PROPOSED BUILDING AMENDMENTS

Gorton Centrepont

Proposed Second Floor Plan (Comparative Overlay)

GCP-KMA-XX-XX-DR-A-7009

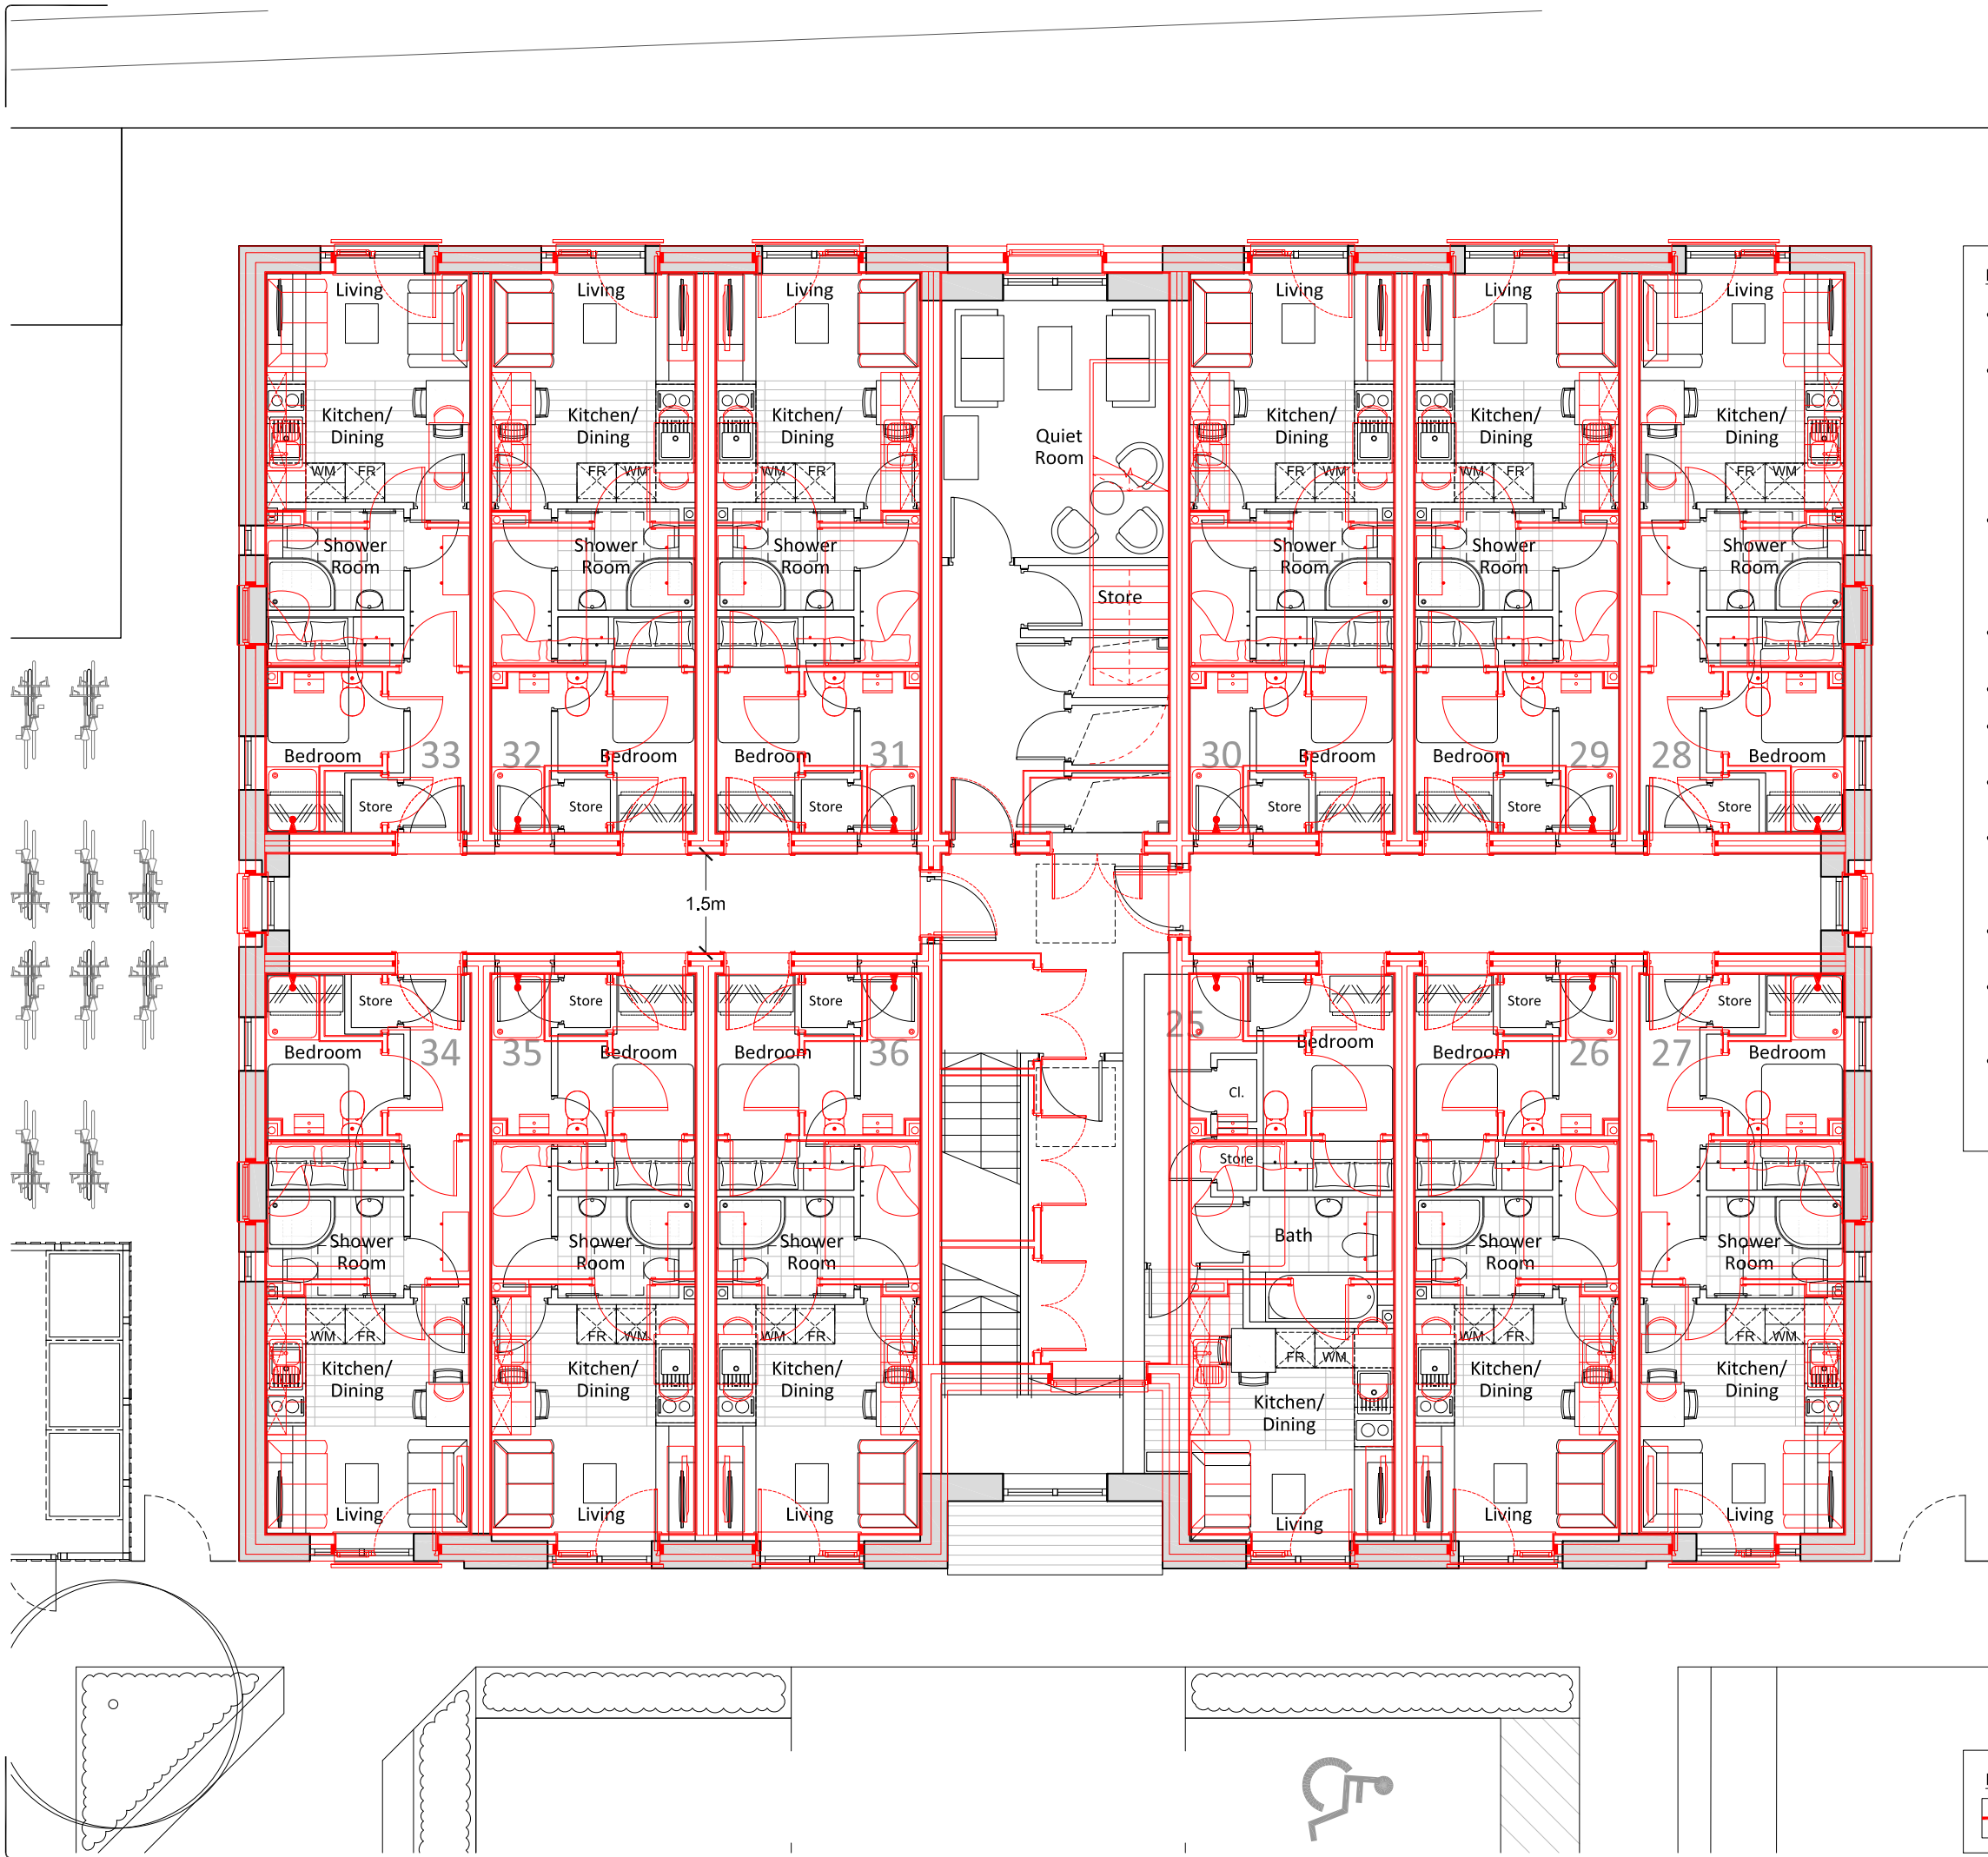
- 2no. (minimal) feature gable projections to be added to the principal elevation.
- The approved flat roof and parapet detail have been replaced with a traditional pitched roof. The proposed ridge height is to remain the same as the approved parapet, but the proposed (lower) eaves height shall reduce the overall visual mass of the building.

- A concealed plant area (securely accessed via the main stair) is located upon the proposed central flat roof section, to be hidden from view by the pitched roof returning front-to-back to form a visual barrier.

- The main entrance is to be pulled forward, but not beyond the approved building line/principal elevation.
- The main entrance is to include for a proposed canopy.

- All solar assisted heating panels are to be removed from the front and rear elevations.
- A PV array is now proposed to the south-facing roof to assist with energy generation.

- All Juliet balconies and associated doors to each apartment are to be replaced with larger openable windows on the front and rear elevations.
- Wall recesses and full-height glazing are to be added to the corridors within each gable end.

- Additional small windows are proposed within each gable end, with no overlooking issues to either the west or east.
- The proposed material palette is to match the adjacent GMYF building in terms of the proposed red facing bricks, artificial slate roof and glazing.
